# SAN FRANCISCO PLANNING DEPARTMENT

**MEMO**

**RE:** Review and Comment at November 20<sup>th</sup> Hearing  
**Alamo Square Renovation**  
Case No. 2013.1334U

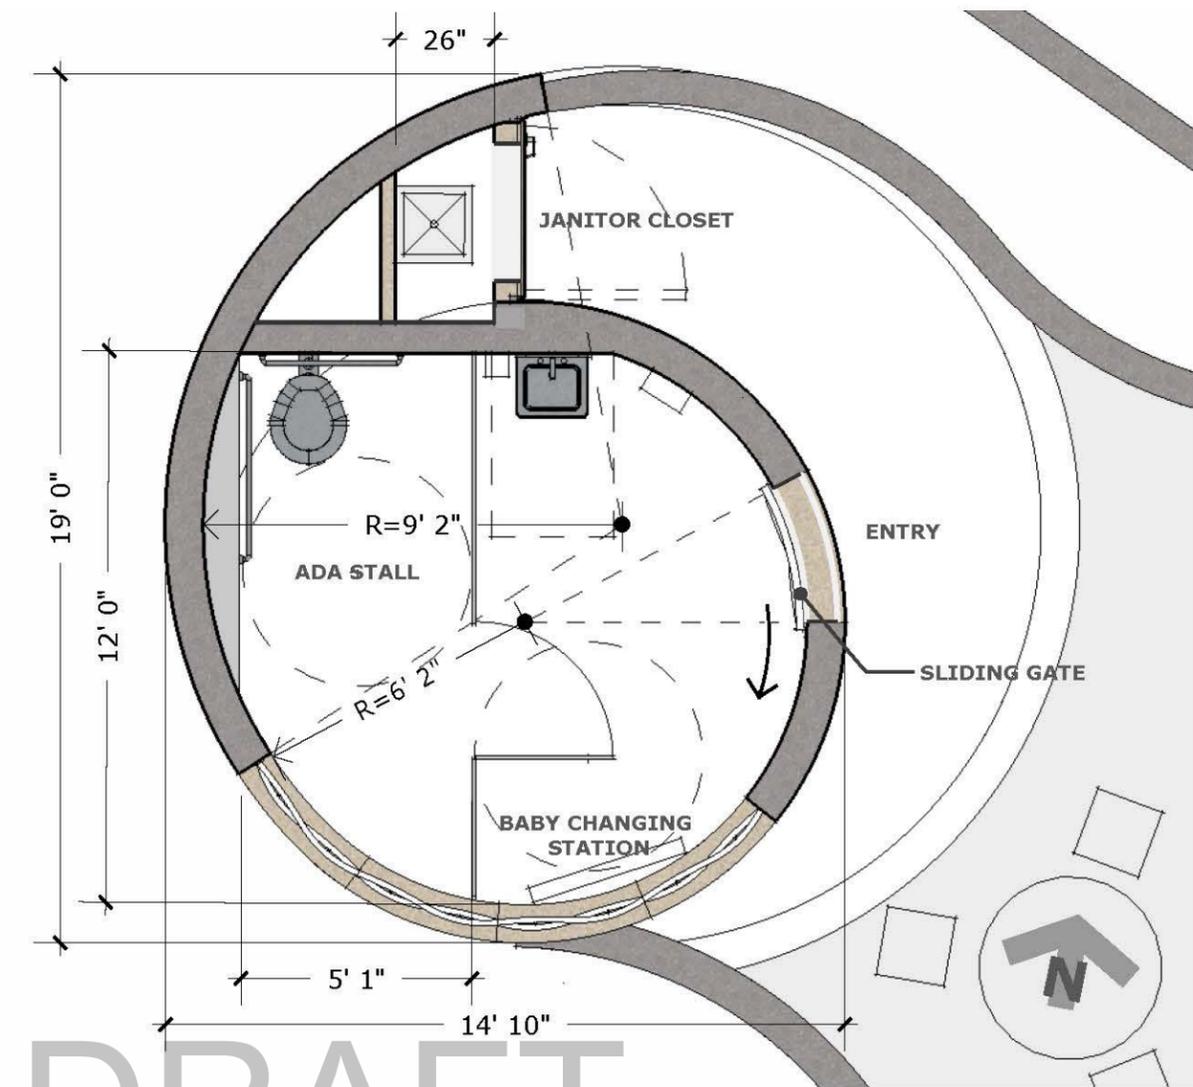
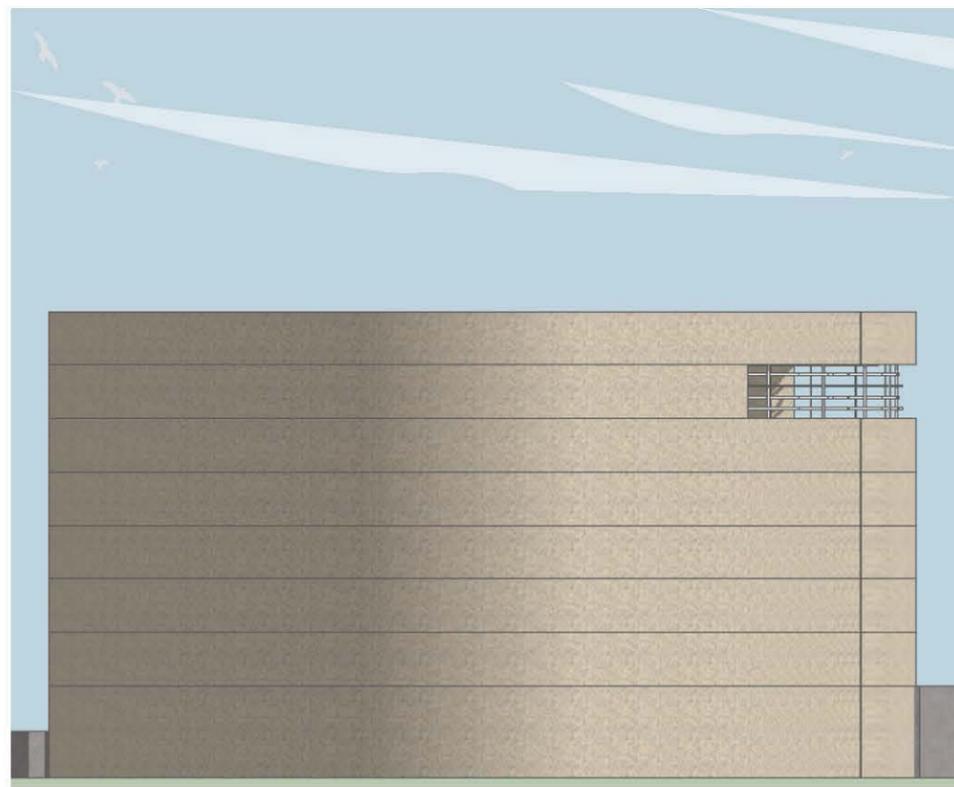
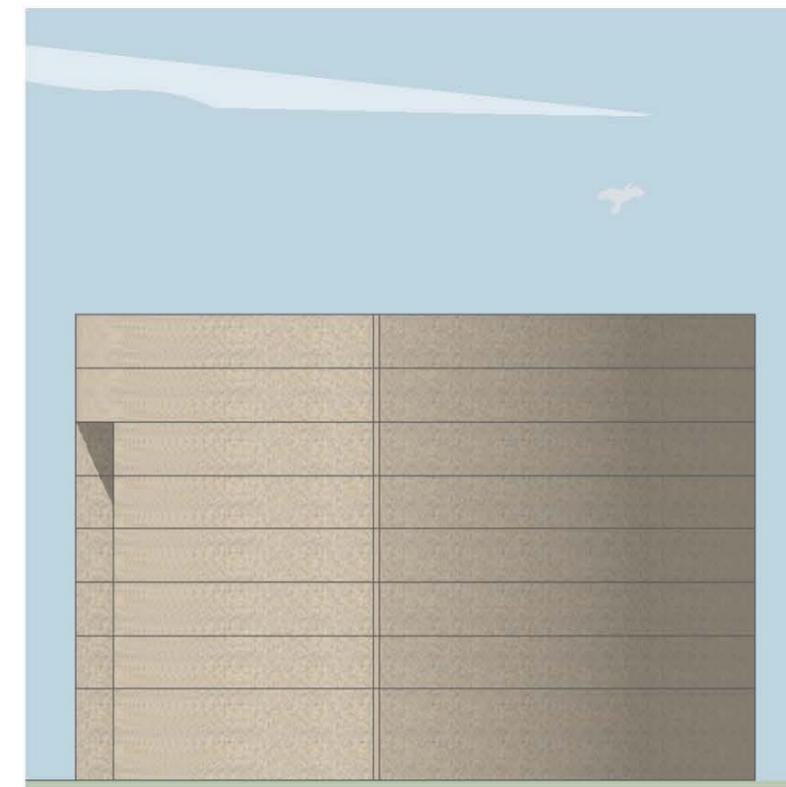
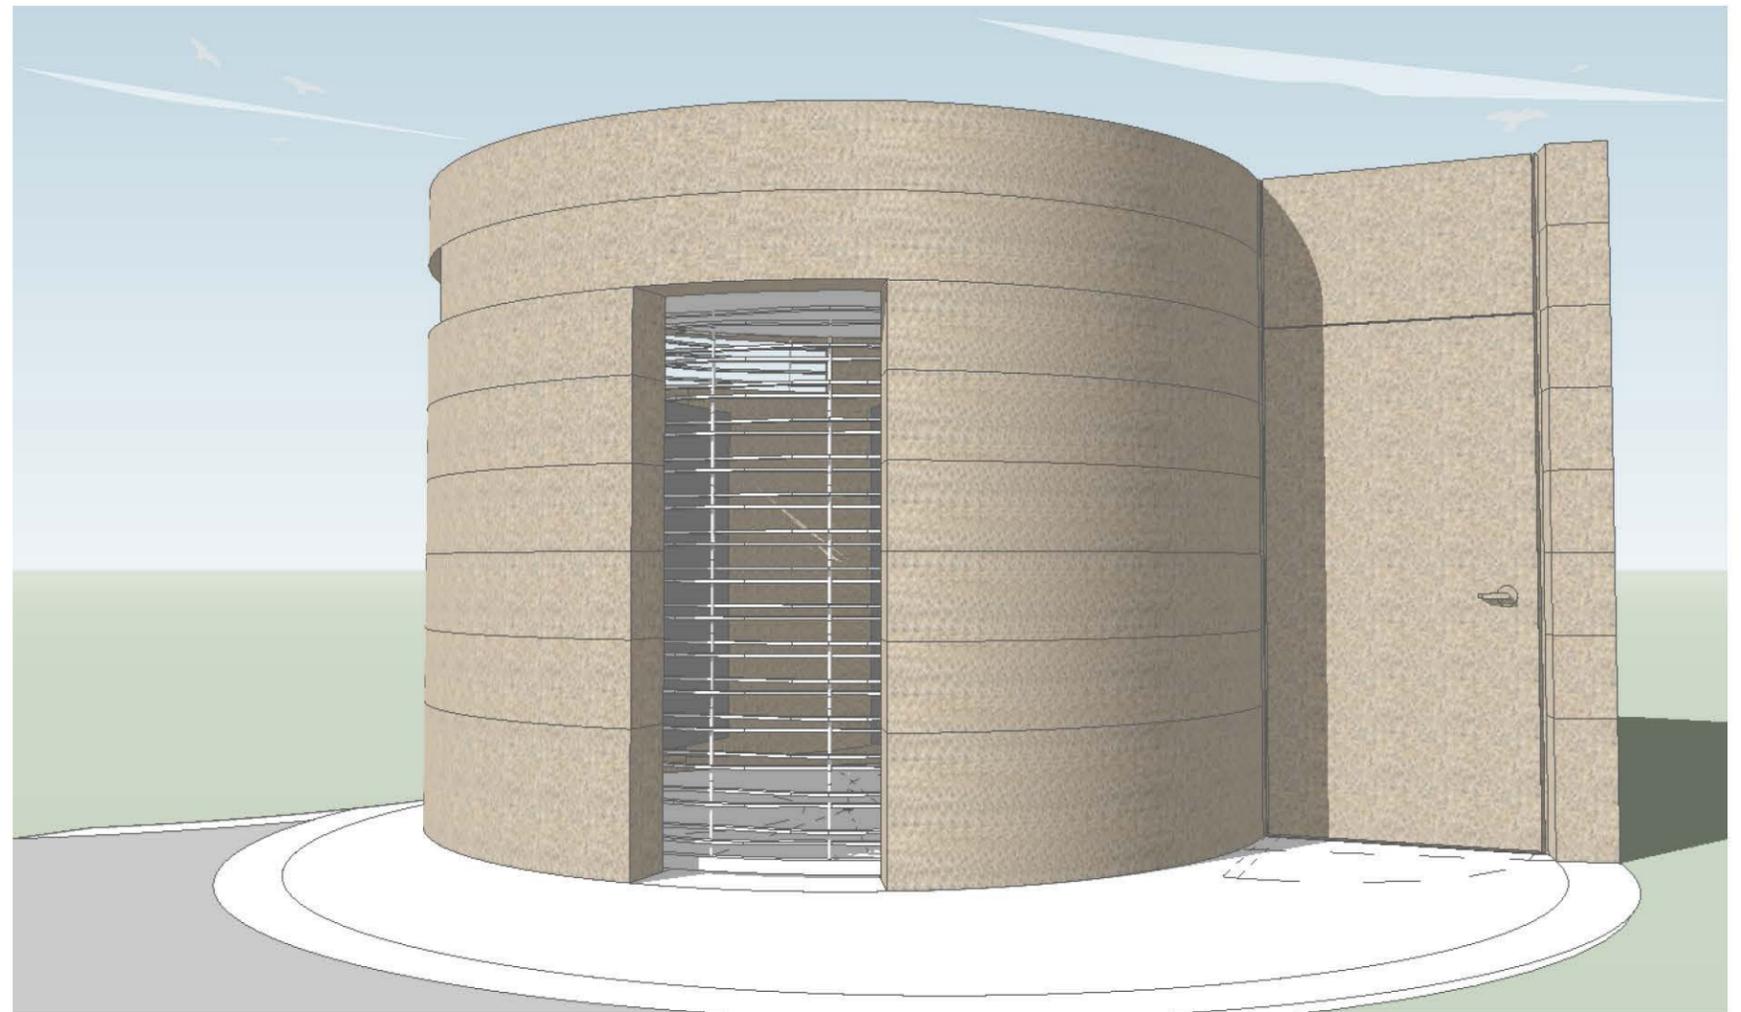
- Create a base and cap for the new restroom building to break up the wall plane and to reflect the classical hierarchy found in the surrounding historic buildings. This should be achieved with contemporary and referential details rather than copying historic motifs from the district.
- Use a painted or powder-coated finish for the metal gate and screens rather than bare metal to relate to the historic ironwork found in the district.
- Use a darker color for the door and wall between the primary cylindrical form and the outer spiraling wall so that the janitor closet door recedes from view.
- Remove the uniform horizontal banding or replace it with a pattern that relates to the historic masonry work found in the district.
